SHUTE MIHALY
& WEINBERGER LLP

Re: Comments of City of El Segundo on LAX Airfield & Terminal
Modernization Project Draft Environmental Impact Report

Proposed condition (DEIR, Fig. 2-13):

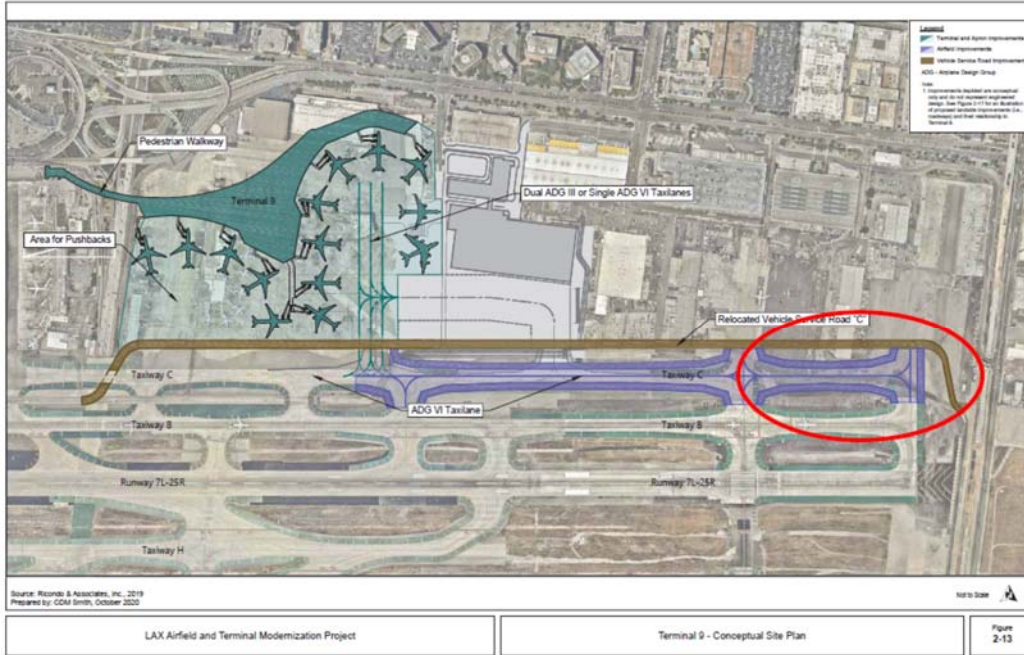
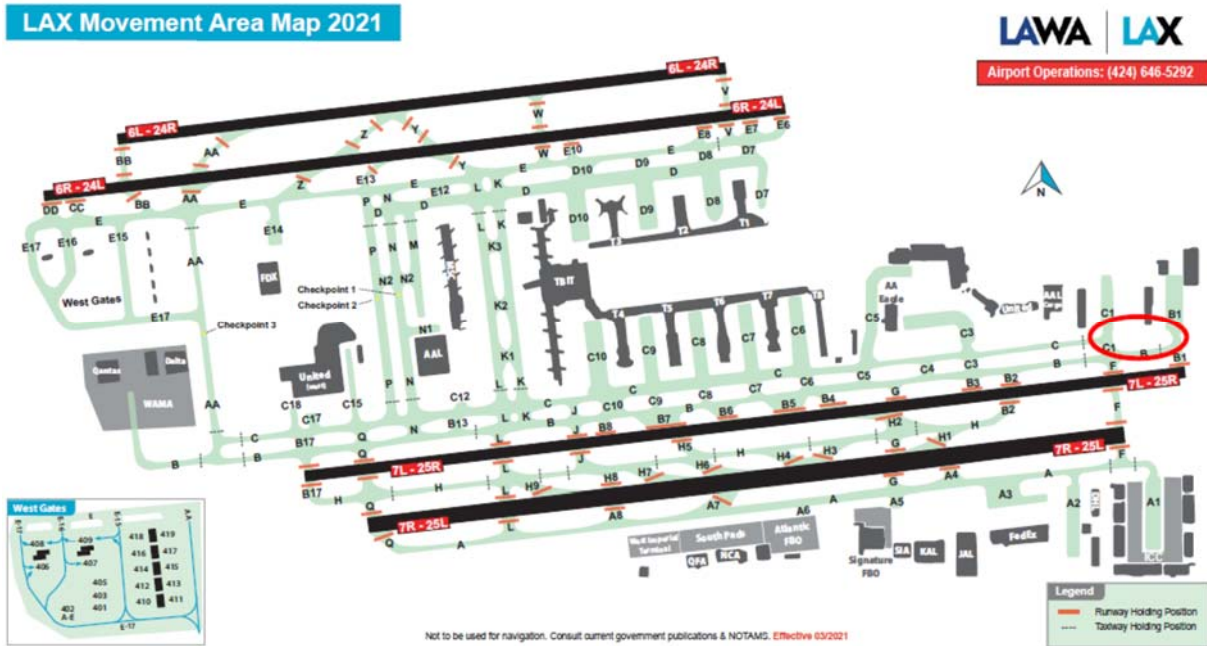
Once again, LAWA is proposing to extend Taxiway C for reasons that are not disclosed and which have no discernable connection to the larger Project.³⁶ In 2012, El Segundo commented that the Runway 7L/25R RSA Project EIR failed to adequately explain the linkage between the RSA improvement and this “associated improvement,” and that if LAWA had another reason for extending Taxiway C, LAWA must disclose that reason.

LAWA’s failure to explain why it needs the Taxiway C extension here suggests that LAWA is trying to surreptitiously slip this long-desired airfield improvement into the ATMP without acknowledging its impacts to operational capacity or land uses to the south of the airport. This perception is underscored by the fact that the DEIR contains no more than the following regarding the proposed Taxiway C extension: “Other related airfield improvements that would support Terminal 9 include the . . . easterly extension of Taxiway C from Taxiway C3 to Taxiway B1 . . . the relocated/extended Taxiway C would be designed at ADG VI separation from Taxiway B.” DEIR at p. 2-28. Furthermore, this cursory description of the Taxiway C extension is misleadingly buried in the description of Terminal 9 (section 2.4.2.2), rather than in the separate DEIR section describing, with a 2-page narrative, other “airfield elements” including the Taxiway D extension and the proposed Runway 6L/24R exits (section 2.4.1).

Based on historical documents, El Segundo believes that LAWA wants to finally build the Taxiway C extension to alleviate the longstanding problem of departing aircraft “queuing” on Taxiways C and B such that they interfere with passenger enplanement/deplanement at Terminal 8. Furthermore, since Terminal 9 would be built between Terminal 8 and the east end of Runway 7L/25R, this queueing could interfere with enplanement/deplanement at Terminal 9 as well. Prolonging the time it takes for departing/arriving flights to pull away from/arrive at these passenger terminals could further contribute to airfield delay that LAWA admits would occur without the Project; moreover, the DEIR fails to clearly state that the addition of Terminal 9 and these new aircraft operations would exacerbate the existing queueing problem if the Taxiway C extension were not built. *See* DEIR at p. 2-28 (vague statement that the proposed Taxiway C extension would “support” operations at Terminal 9). The Taxiway C

The DEIR’s description of the proposed extension is fatally flawed and the document does not analyze how this Project component would impact El Segundo. If LAWA intends to keep the Taxiway C extension, it must first revise the DEIR to include

2016 Burbank Project EIR, Appendix K – Noise Technical Report, Fig. K-9:

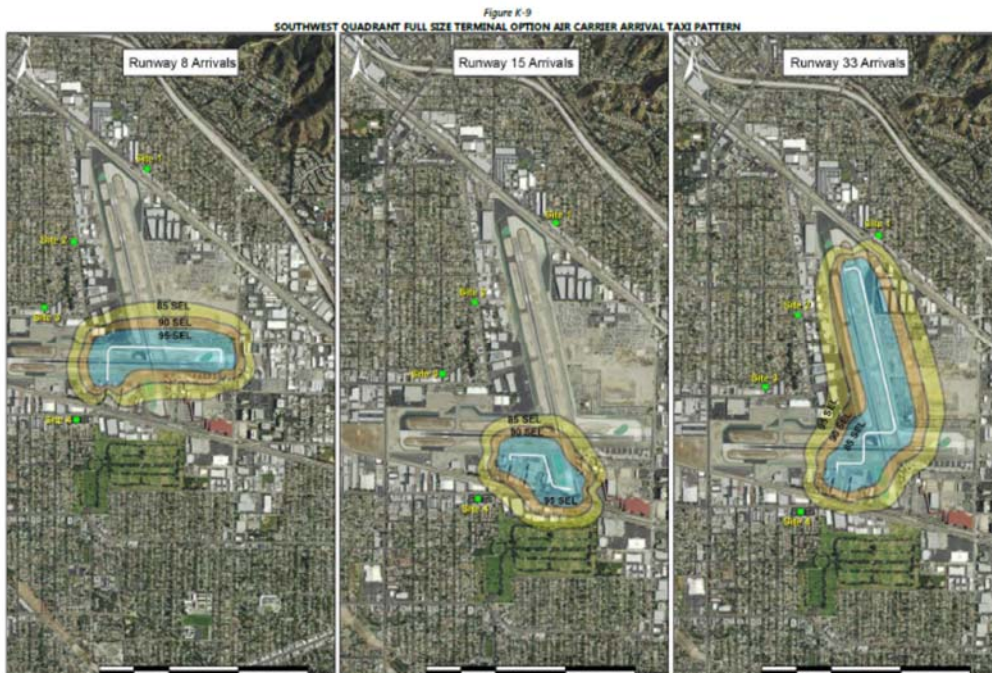
Similarly, the Noise Assessment for the Norman Y. Mineta San Jose International Airport Master Plan EIR (2019) presents Time Above (“TA”) values for aircraft noise levels greater than 75 dB and 85 dB at various receiver points, along with the overall land area exposed to the SEL values for the departure and arrival of various aircraft types, and SEL results for the predominant aircraft in the fleet mix. 2019 SJC Airport Master Plan Amendment EIR, Appendix J - Noise at Table 12, Table 13 and Table 14. The EIR also notes that an earlier (2003) EIR contained a similar analysis comparing existing and future SEL conditions and identified increases in SEL values in the airport vicinity. *Id.* at p. 25.
